BOS BLOCK 1 Full Work Group Response

Presentation to: Massport CAC

Date: October 18, 2018

RNP RWY 33L and GPS RWY 33L with RNAV Visual

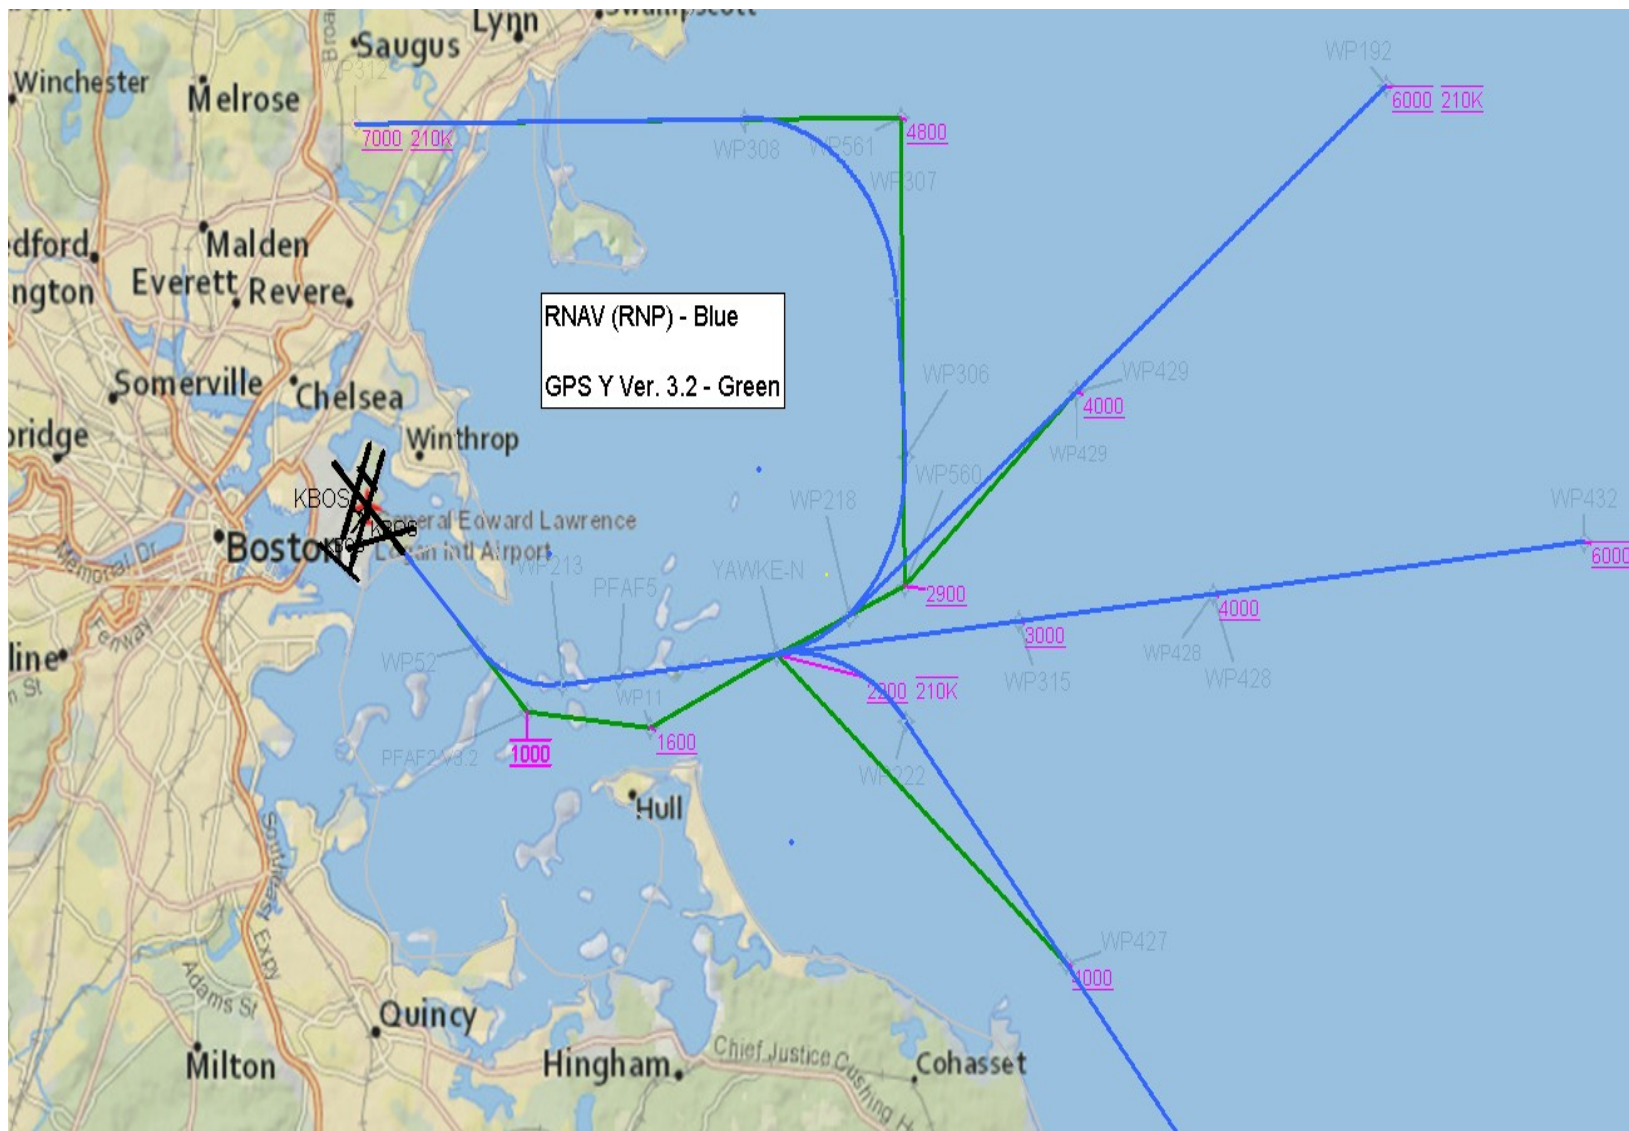
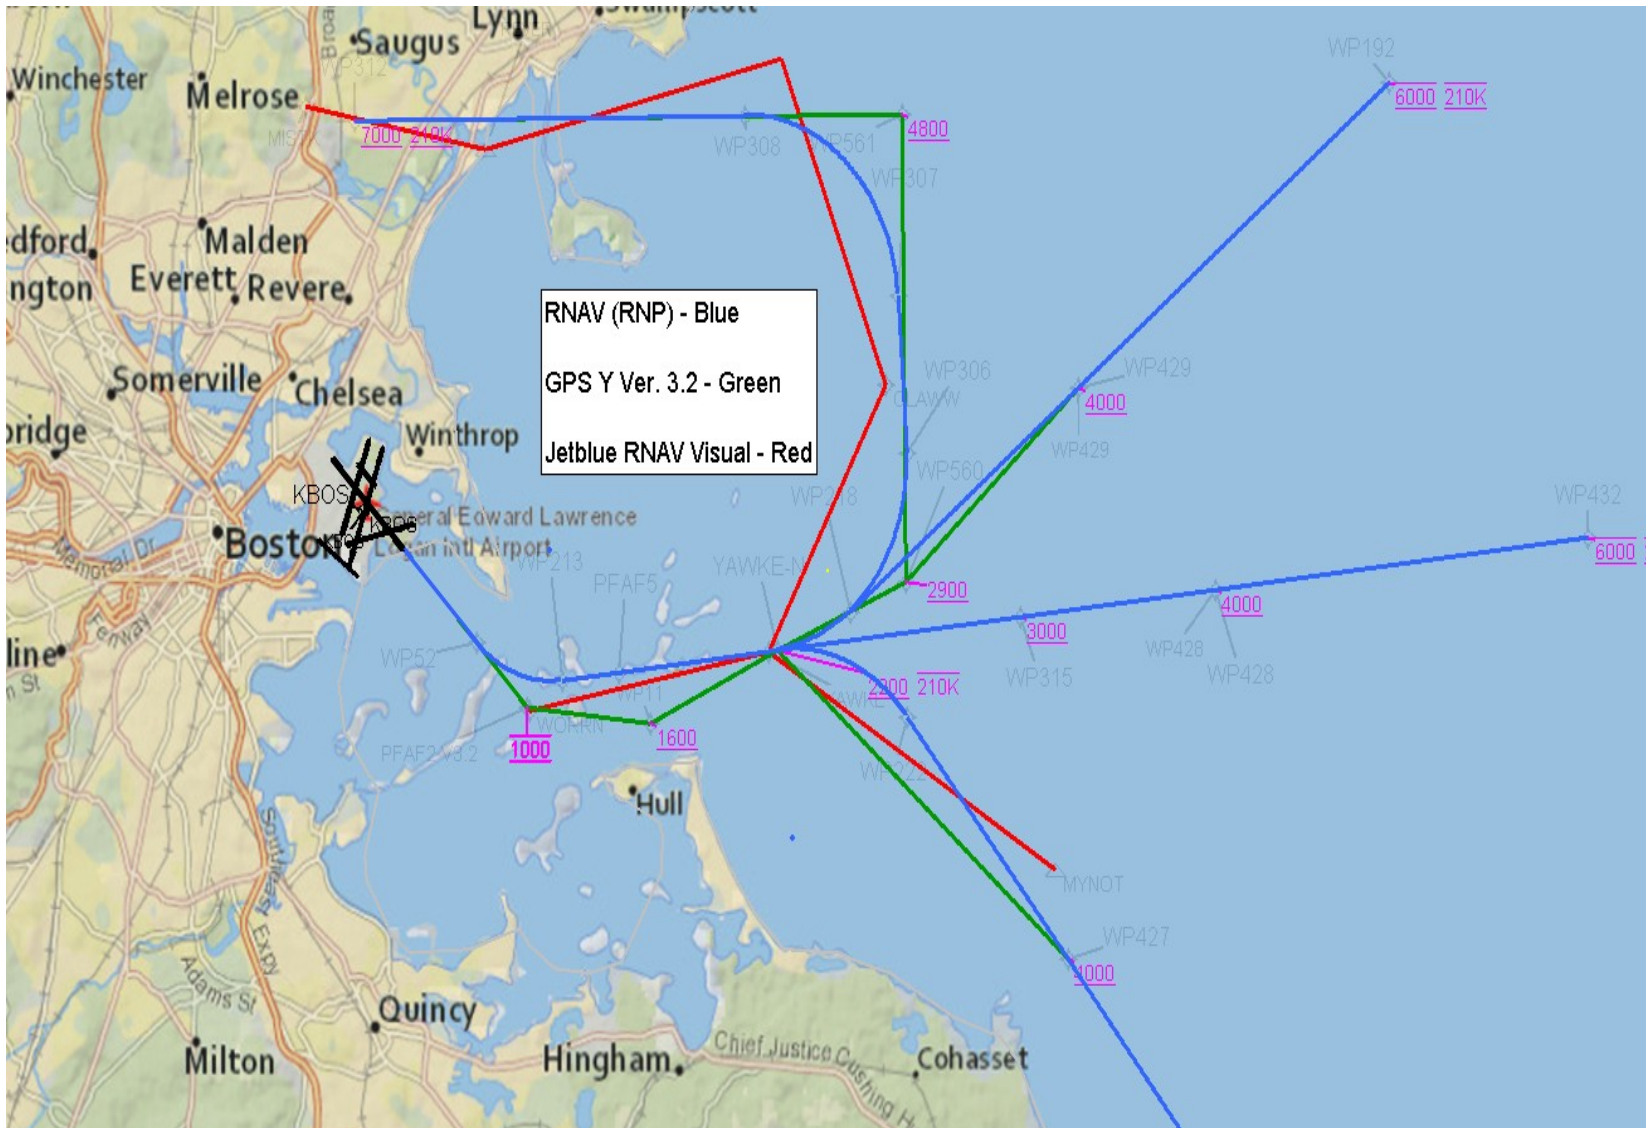
- ❖ **Use of RNP RWY33L will be limited when all traffic is not able to accept clearance**
- ❖ **RNP RWY 33L and ILS RWY 33L are not able to be used simultaneously due to dissimilar tracks and lack of sequencing tool**
- ❖ **RNP RYW33L and GPS RWY 33L can be used simultaneously due to similarity of track paths**
